Subject: Raw Wastewater Pumping Station
Nevada, Iowa
C190845 04

1. Date	:	1-7-92	13. Decision:	Denied
2. Review Engineer	:	Terry Kinschman	Date:	1-10-92
3. Date Received	:	2-11-91		
4. Facility Name	:	Neosho	14. Appeal:	
5. County Number	:	85	Date:	
6. Program Area	:	CP		
7. Facility Type	:	005		
8. Subject Area	:	Pumping Station Capacity		
9. Rule Reference	:	900 - 64.2(9)a		
10. Design Std. Ref.	:	13.4.1		
11. Consulting Engr.	:	Snyder and Associates, Inc.		
12. Variance Rule	:	900 - 64.2(9)c

NEVADA, IOWA
WASTE WATER TREATMENT PLANT
IMPROVEMENTS
RAW WASTE WATER PUMPING
STATIONS

RE: NEVADA, IOWA
WASTEWATER TREATMENT PLANT IMPROVEMENTS
REQUEST FOR DESIGN VARIANCE - RAW WASTEWATER PUMPING STATION
PROJECT NO. 89-206-G

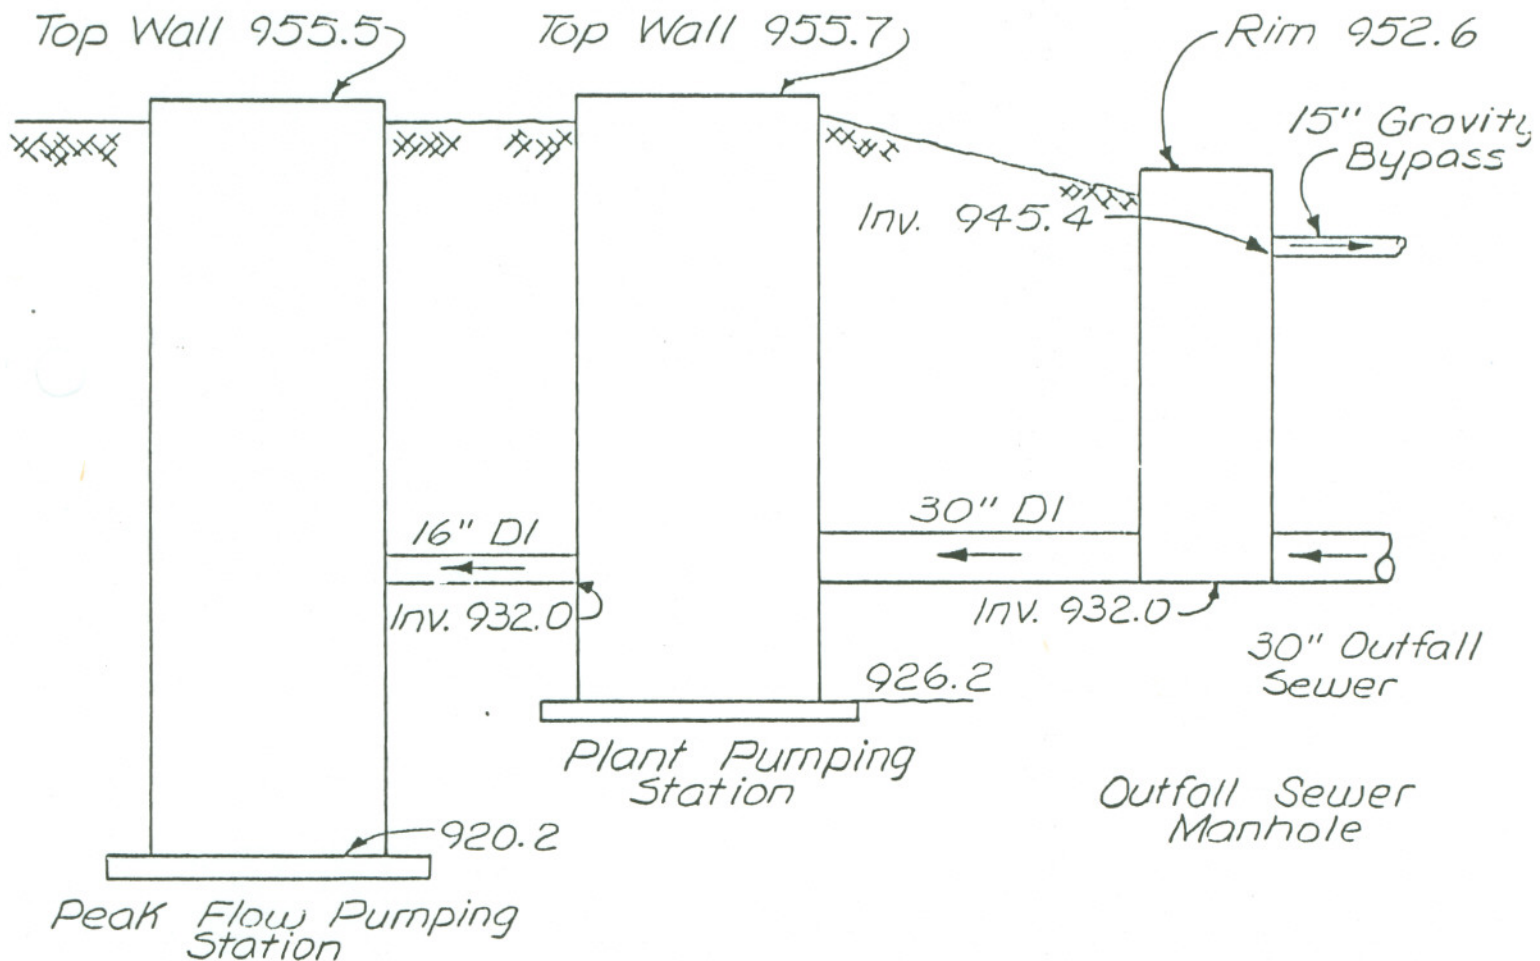
32. Drawings 6 and 20. A Design Variance for the Raw Wastewater Pumping Station was requested on February 11, 1991 to allow consideration of the use of on-site standby pumps that could be installed in the event of pump failure in lieu of firm installed pump capacity with the largest pump out of service. The design variation as proposed is reasonable and cost effective and will provide the dependability and reliability that is required.

Attached is a sketch showing the outfall sewer, raw wastewater pumping stations and gravity bypass elevations. The gravity bypass is located as high as possible and the outfall sewer will be surcharged in excess of 13 feet before any flow would be bypassed.

The gravity bypass line is located at an elevation to limit bypassing at upstream manholes on the sewer outfall line. The bypass line is needed to limit damage to the upstream outfall sewer lines and manholes in the event the pumping system including pumps and standby electrical generator would fail. Bypassing at any time is not desirable but it is better controlled and will have less impact on the environment if the bypassing occurs at the Wastewater Treatment Plant rather than at upstream manholes on the sanitary outfall sewer.

A plant effluent flow meter is requested in your comment number 29. This meter which will measure the total effluent flow including any bypassed flow is added on Drawing 6 and Specification Section 11301. Plugging the gravity bypass line is not reasonable or prudent.

Nevada, Iowa
Wastewater Treatment Plant Improvements
New Wastewater Pumps

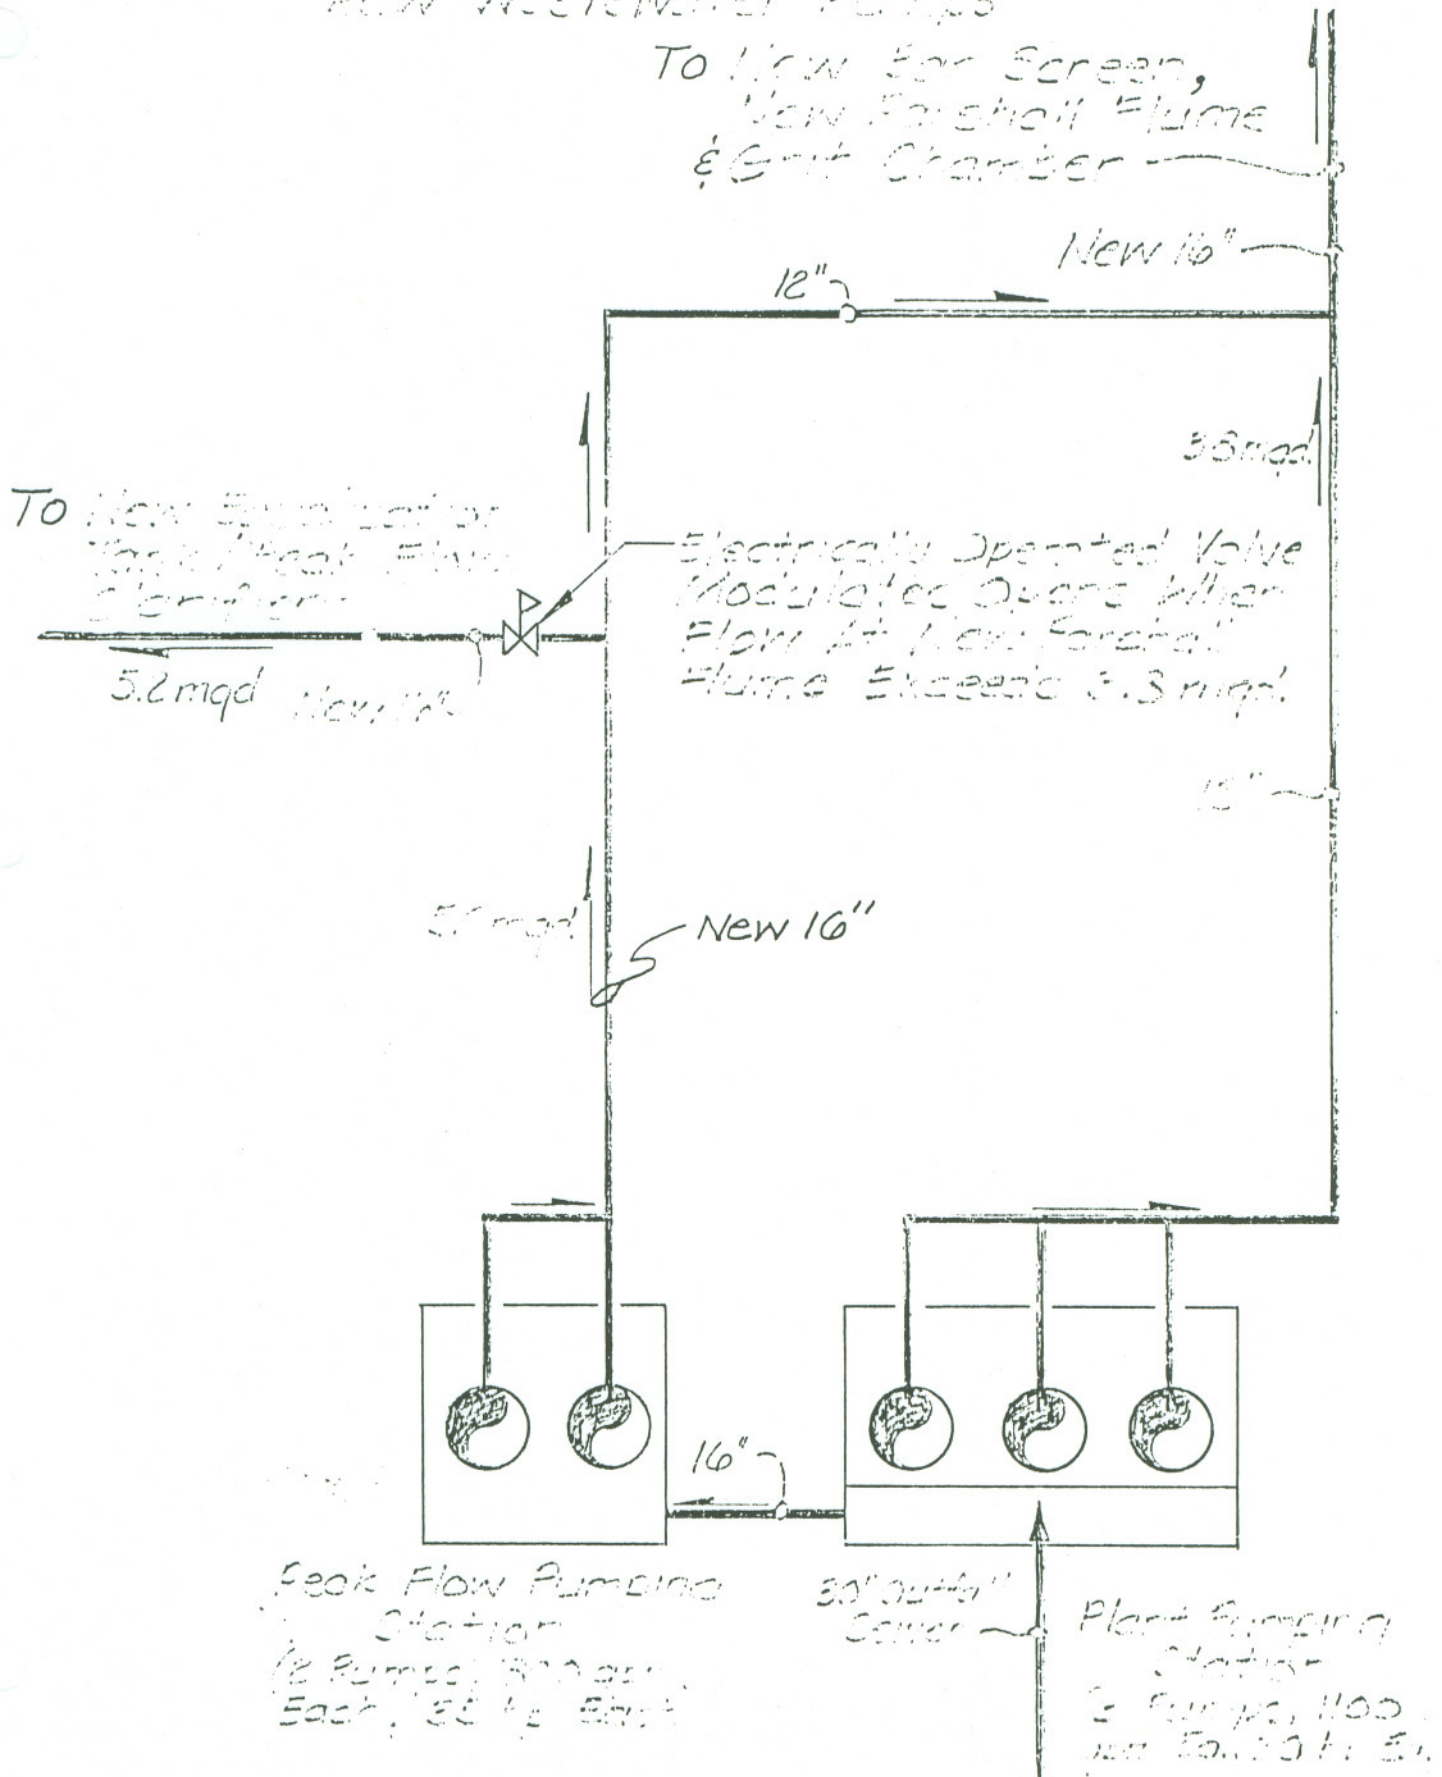
We request a design variance to allow the use of all the existing raw wastewater pumps to meet PHWW flows. We propose that the City purchase and maintain a spare pump of each size at the Wastewater Treatment Plant for installation if a pump should fail. The existing piping and pump installation is such that pump replacement can be done in approximately two hours.

The raw wastewater pumping facilities at the Nevada Wastewater Treatment Plant include two pumping stations. The attached sketch shows the piping arrangement and operation.
